PLANNING & ZONING BOARD STAFF REPORT

Layton Pointe Plat

Meeting	File No.	Application Type
April 21, 2025	2024-109-PMA-PZB	Preliminary Plat and Final Plat
Applicant	Owner	Authorized Agent
Toll Southeast LP Company, Inc.	Toll Southeast LP Company, Inc.	Brian Terry, PLA, Insite Studio Christina Bilenki, Esq., Dunay, Miskel & Backman, LLP

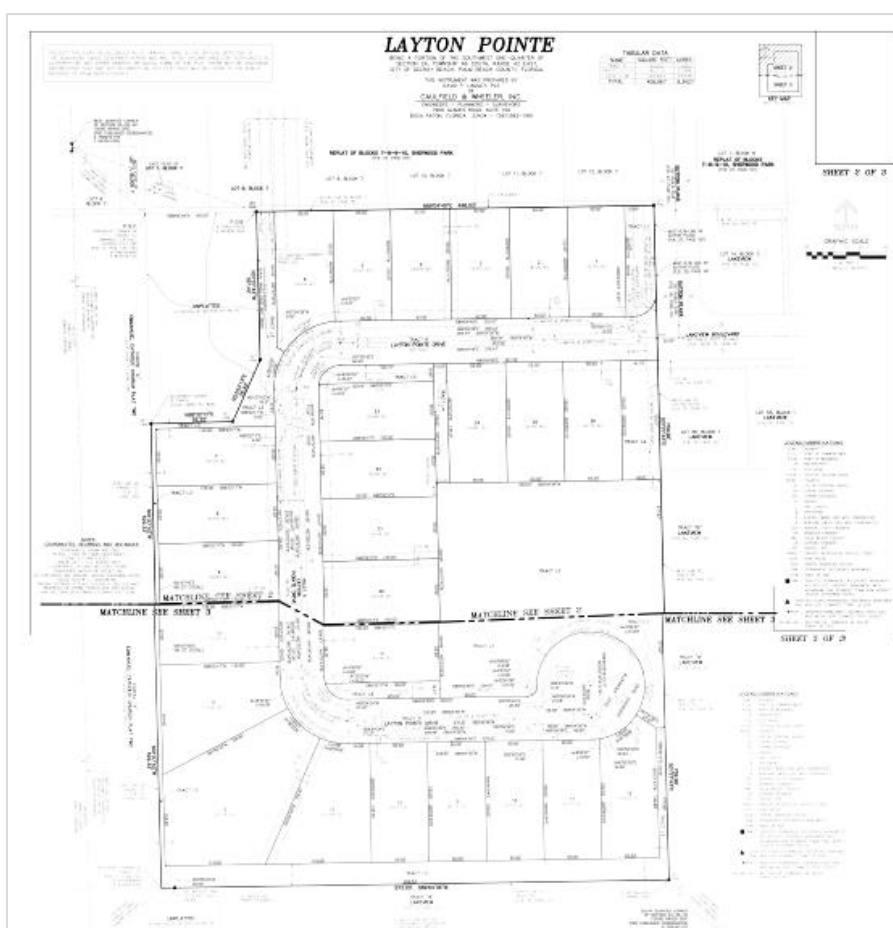
The replat consists of 9.34 acres of land currently addressed as of 3900 Sherwood Boulevard. The Layton Pointe Plat proposes 26 conventional fee-simple single-family lots, with 2.198 acres of open space (image at right, attached full-sized).

The open space areas are 23.35 percent of the total plat (image at right). The development of each single-family lot will be subject to the minimum open space requirements in the R-1-A zoning district; a minimum of 25 percent non-vehicular open space must be provided on each lot.

Open space Tract L7 has a children's play area, with benches a walking trail; details will be approved as part of the site plan for the common areas. The applicant has preserved a specimen size Ficus tree (weeping fig) adjacent to the log pile play area, and benches will be provided along a lighted walking trail for access from the north to the play area and the mail kiosk.

1. The restriction on Lot 26 should be added to the plat.
